TSGR1#7(99) a80

RAN WG1	meeting #	7	TSC
Place	:	Hanover	
Date	:	August 30 <sup>th</sup> to September 3 <sup>rd</sup> , 1999	
Title	:	Text proposal for DL rate matching signalling	
Source	:	Mitsubishi Electric (MCRD)	
Paper for	:	Decision

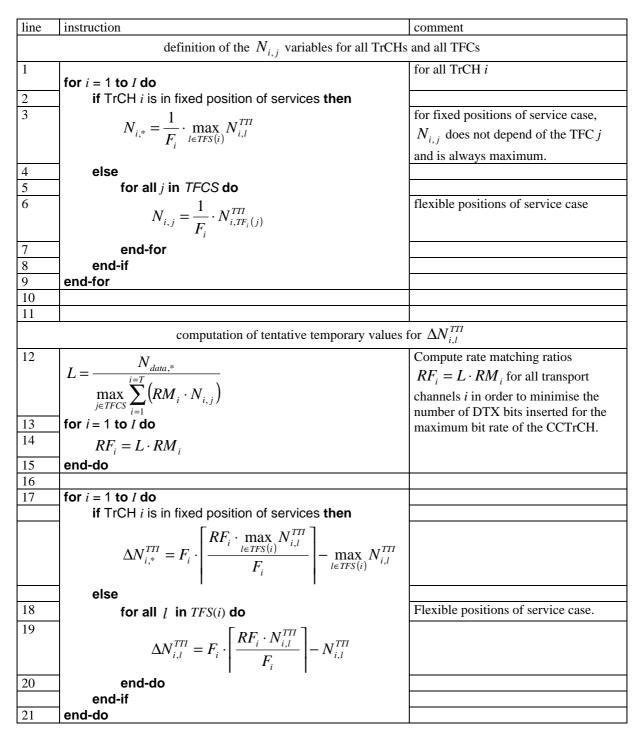
From line 1 to 9 lies the definition of the intermediate variables  $N_{i,j}$ . It is to be noted that for the flexible position case, the expression at line 6 is changed compared to the current rule as the ceiling ([.]) is no longer taken. This is possible because for DL  $N_{i,j}$  is not the positive integer size of a real data block, but just an intermediate variable. Also a new expression is given at line 3 for the fixed position case.

From line 12 to 36 lies the algorithm itself. This algorithm comprises two phases. In a first phase, from line 12 to 21, tentative temporary values for the  $\Delta N_{i,l}^{TTT}$  are computed. These temporary values ensure that a minimum number of DTX is inserted when the bit rate of the CCTrCH is maximum, but they don't ensure that the bit rate of the CCTrCH is always within the  $N_{data,*}$  limit.

So a second phase of checking and correction is needed. This second phase is lying from line 23 to 36.

At the end of the second phase the latest values of the  $\Delta N_{i,l}^{TTI}$  are the definitive values.

Finally, it is to be noted that  $\Delta N_{i,l}^{TTI}$  determined by the algorithm below are such that  $N_{i,l}^{TTI} + \Delta N_{i,l}^{TTI}$  is always a multiple of  $F_i$ . So in DL with this new rule, the "size equalisation" step is not needed.
